CALL NO. 313
CONTRACT ID NO. 101318
ADDENDUM # 1

Subject: Floyd County, JL03 036 0122 027-028
Letting June 25, 2010

- (1) Revised - Plan Sheets - R7, S1, S2, S14, S17, & S20
- (2) Revised - Utility Notes - Page 11 of 168
- (3) Revised - Communicating All Promises (CAP) - Page 92 of 168
- (4) Added - Permit Application - Pages 117(a)-117(t) of 168

COUNTY OF	ITEM NO.	SHEET NO.
FLOYD	12-8404.00	R7

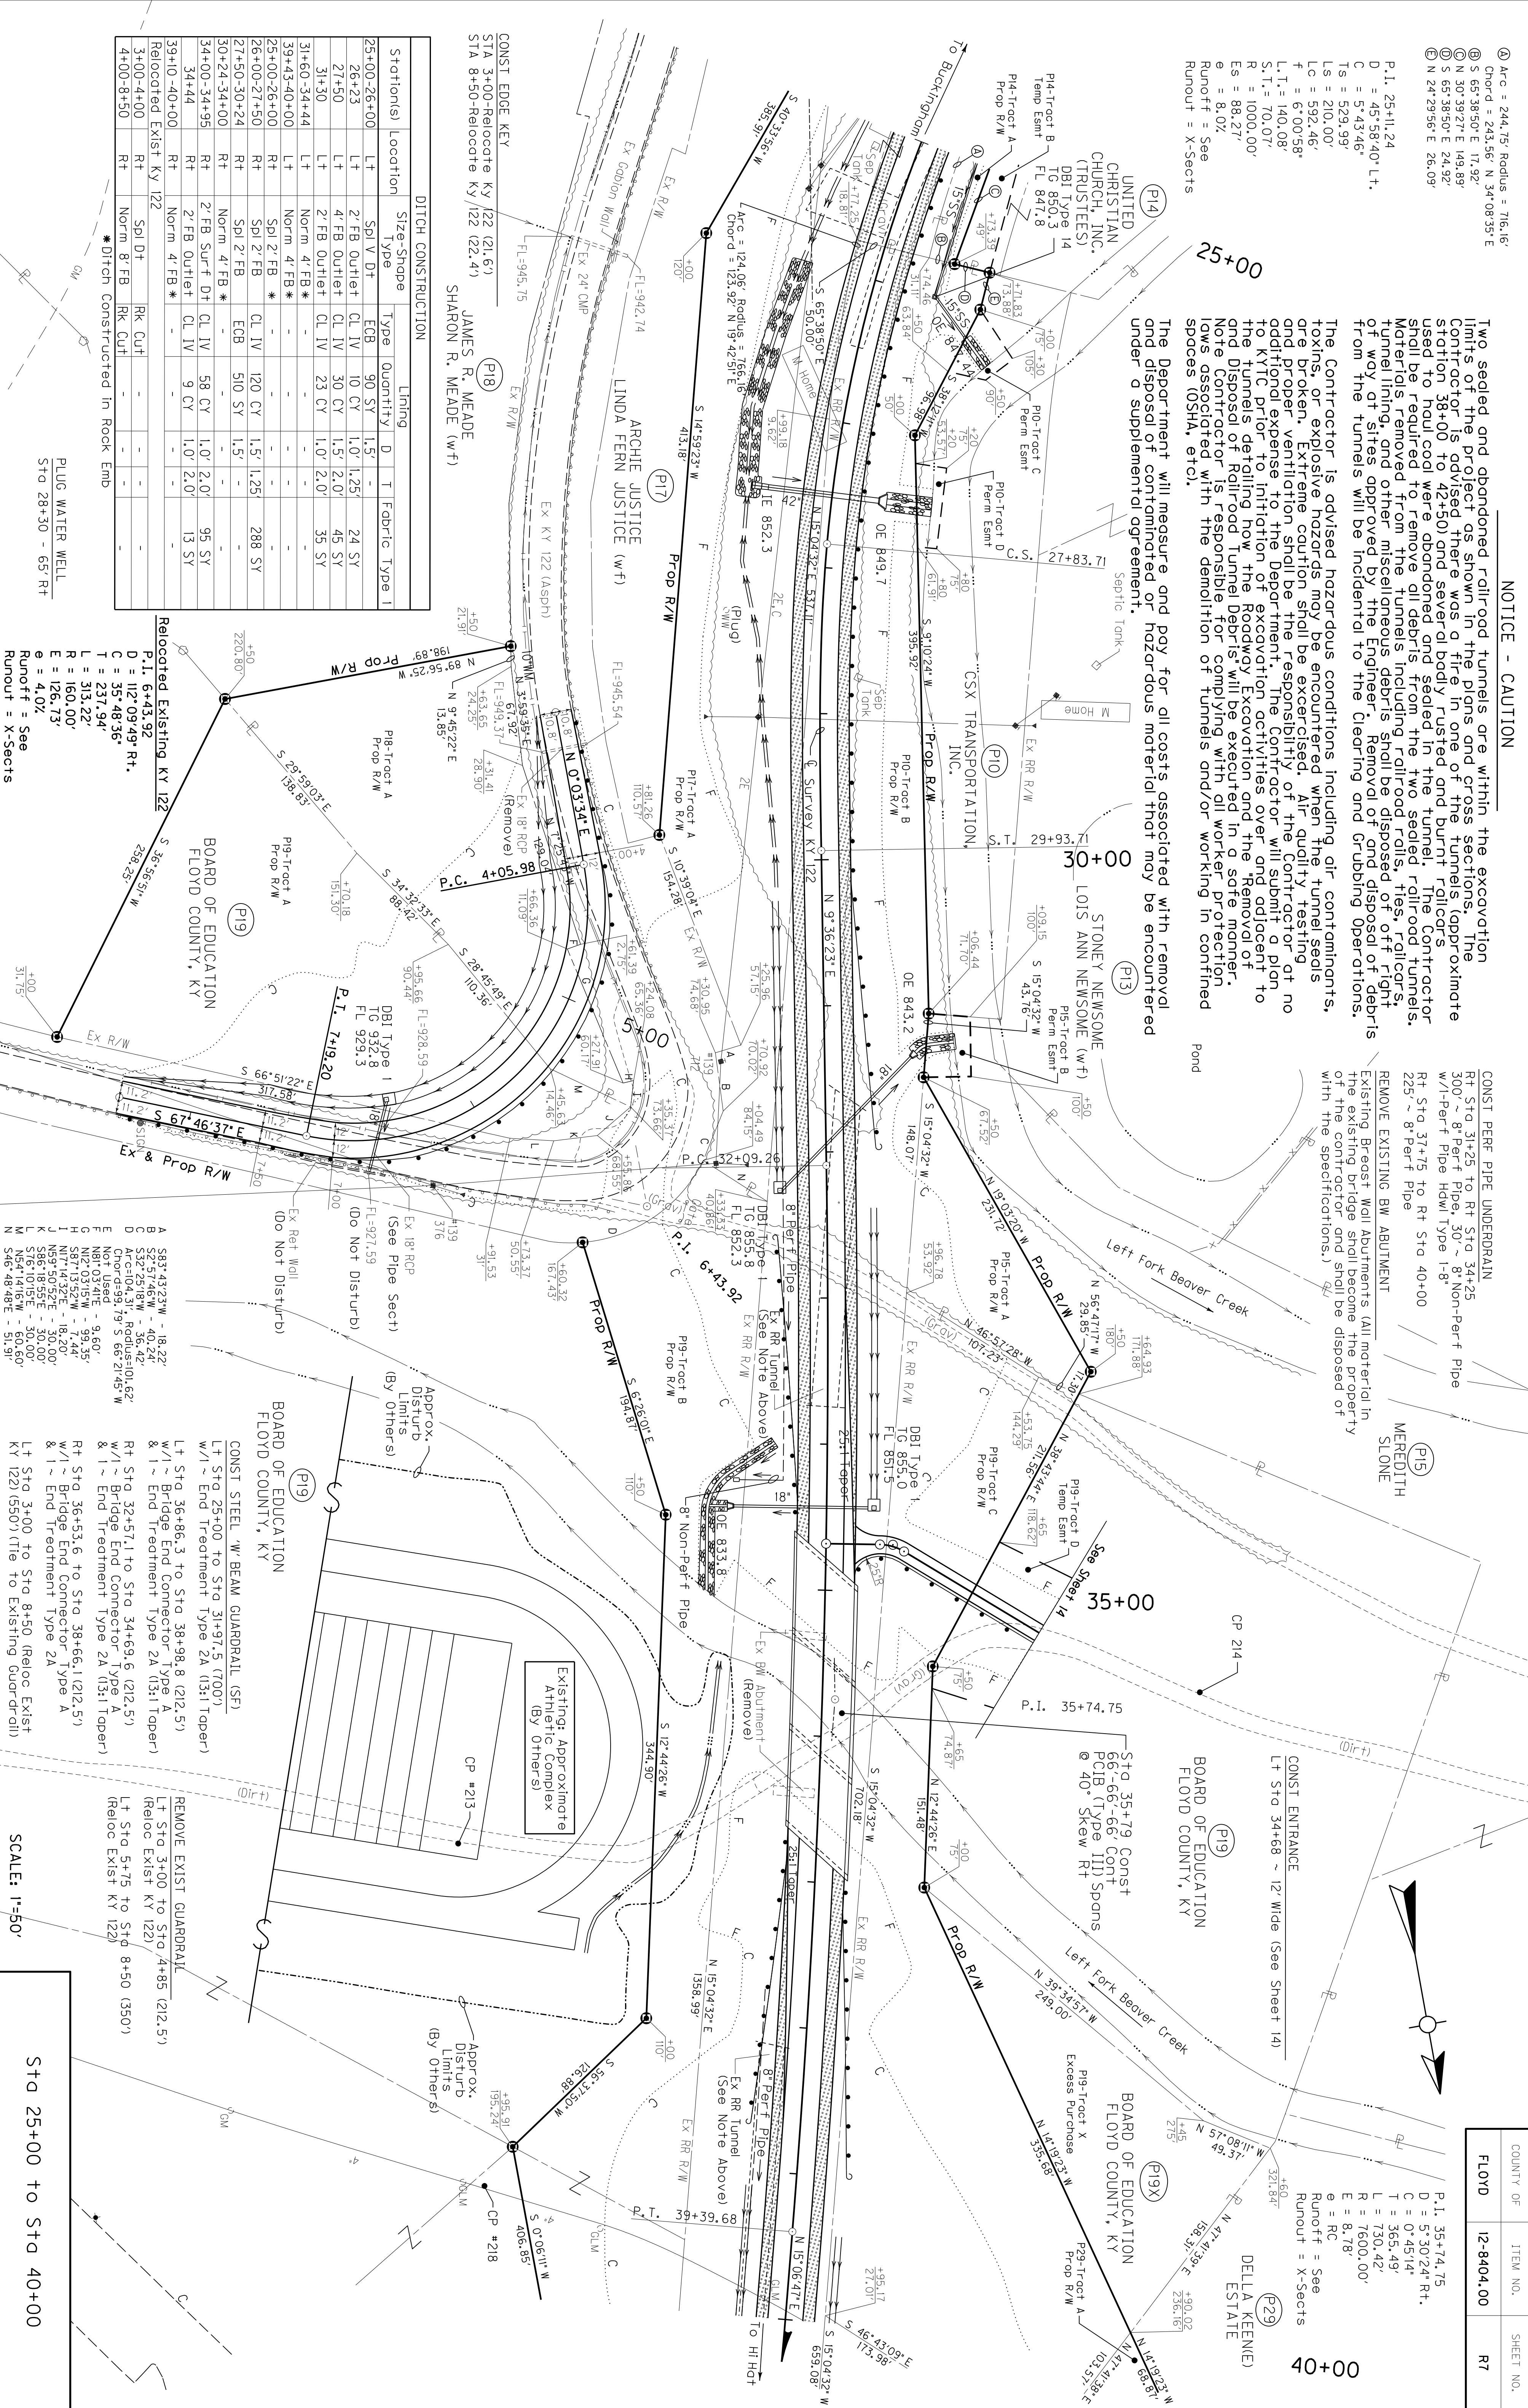
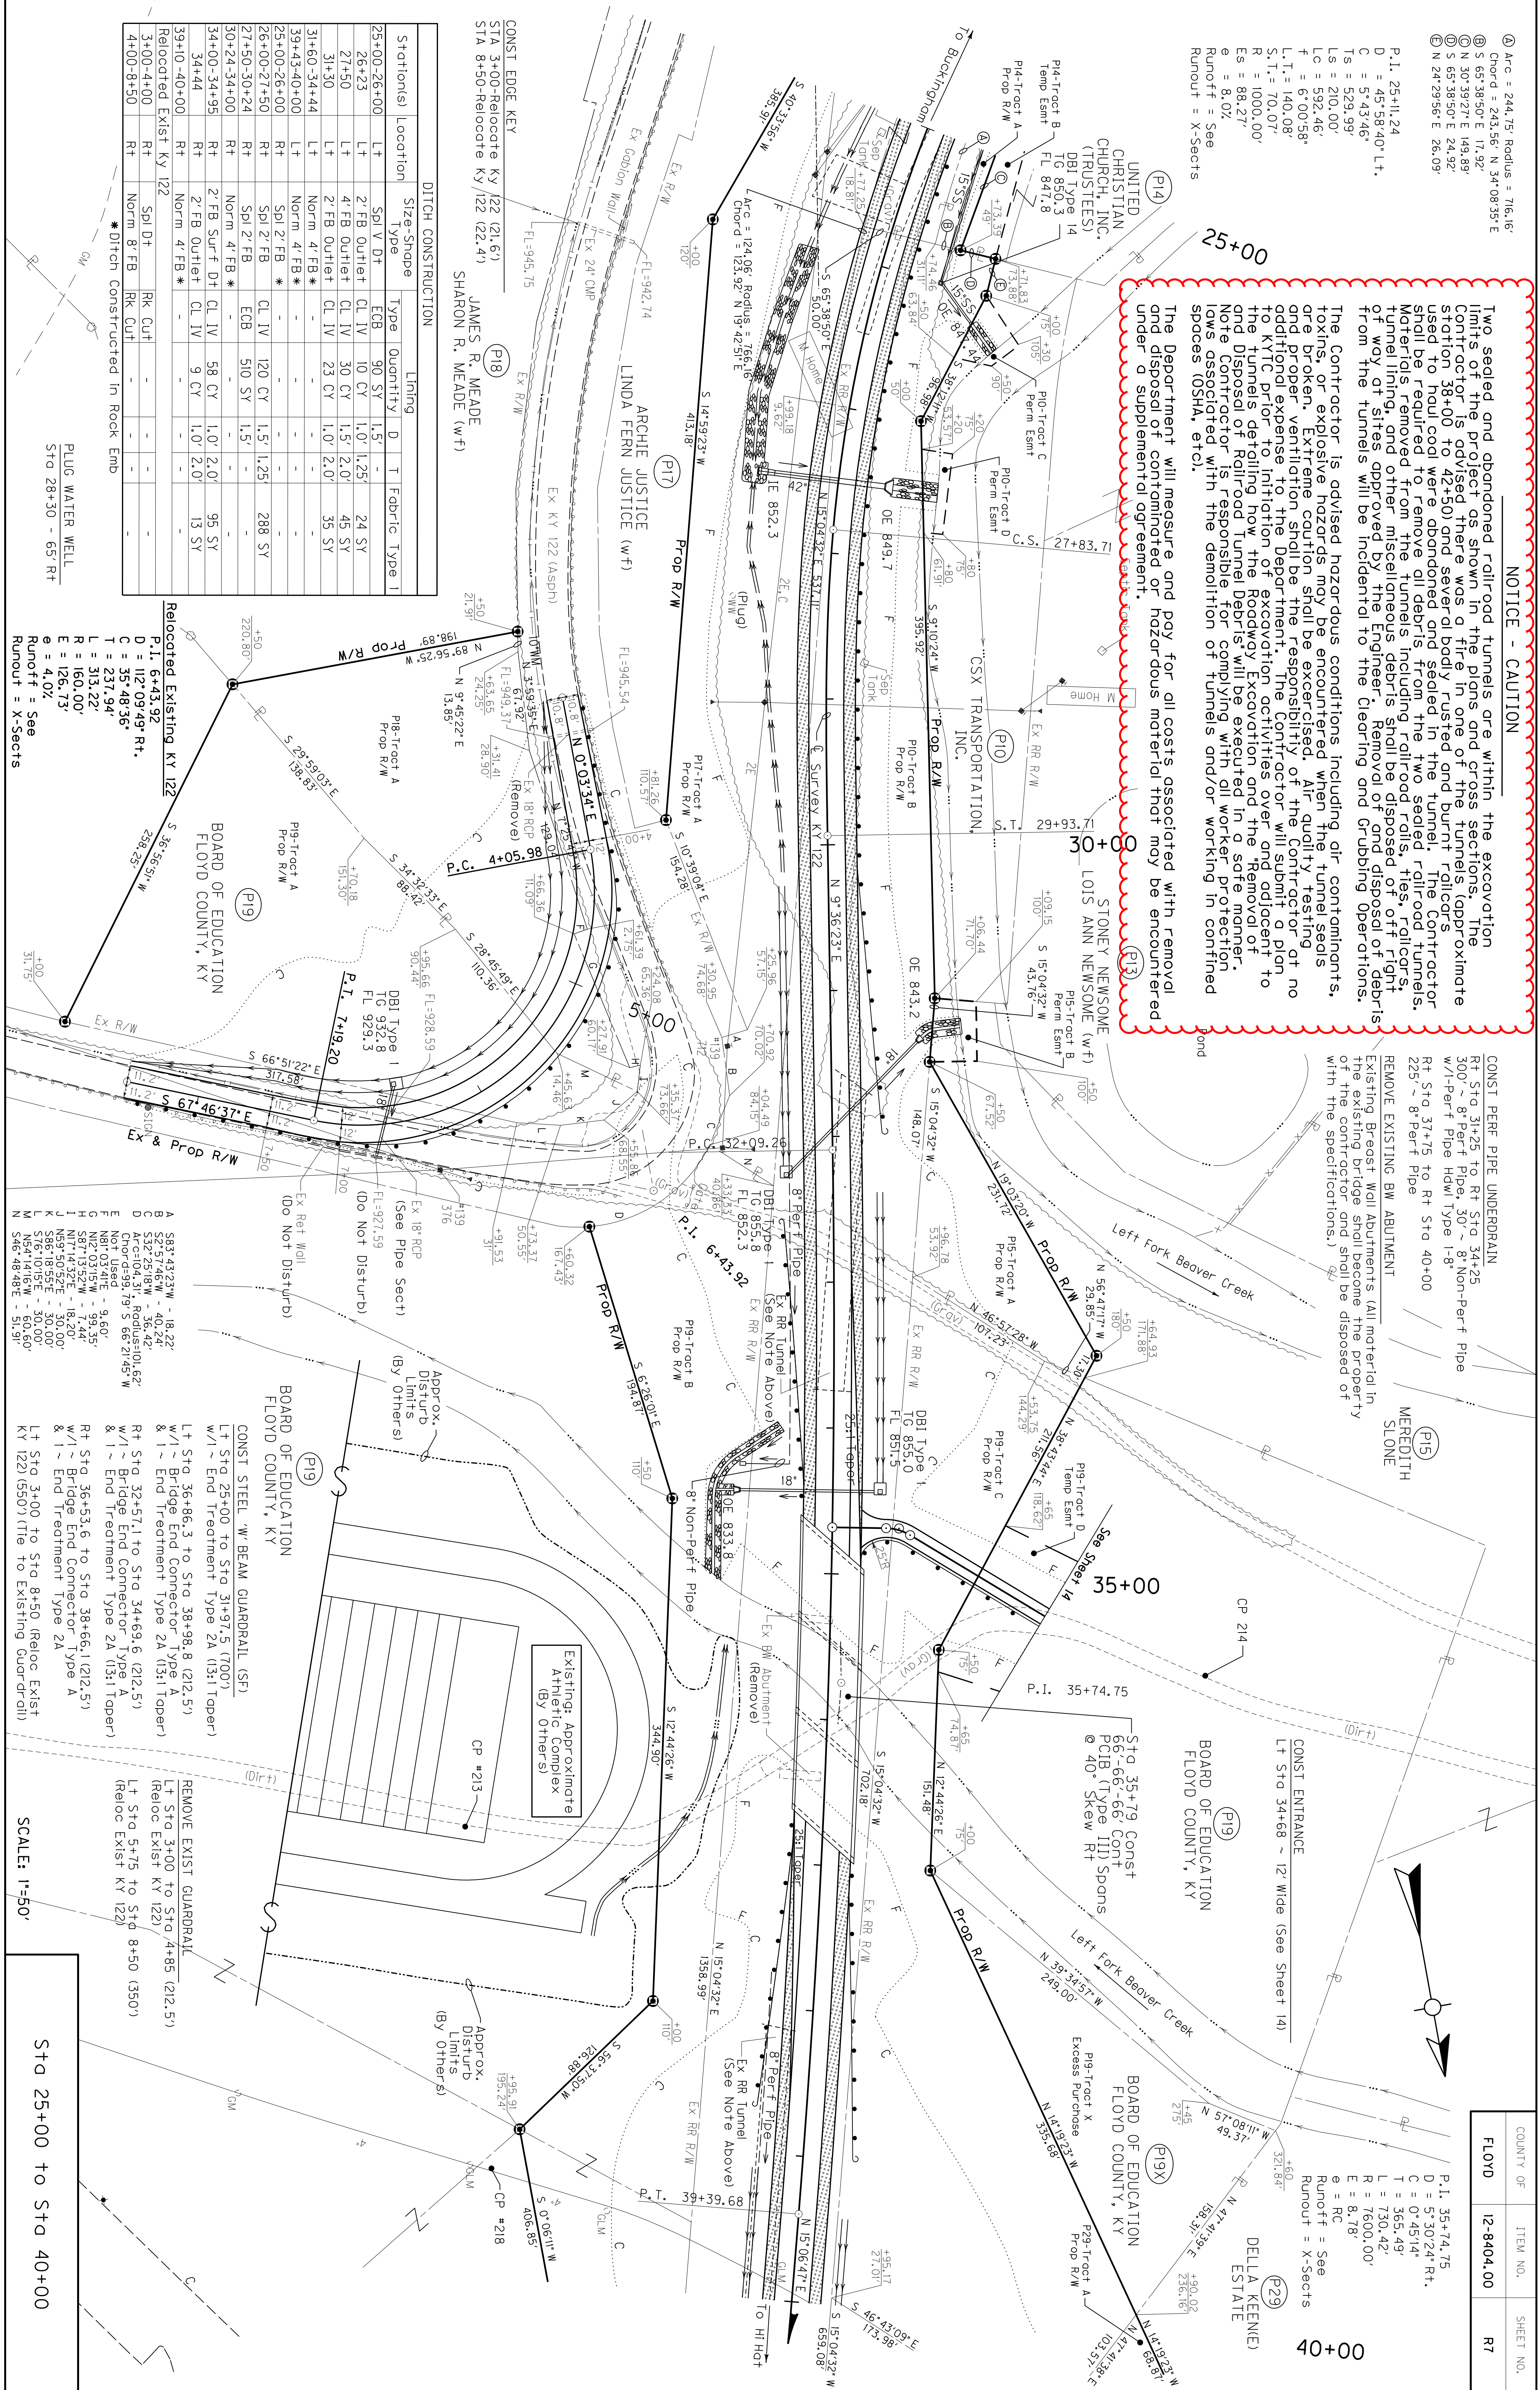
CONST STEEL W/ BEAM GUARDRAIL (S/F)
Lt Sta 25+00 to Sta 31+97.5 (700')
w/1 ~ End Treatment Type 2A (13:1 Taper)
Rt Sta 32+57.1 to Sta 34+69.6 (212.5')
w/1 ~ Bridge End Connector Type A
& 1 ~ End Treatment Type 2A (13:1 Taper)
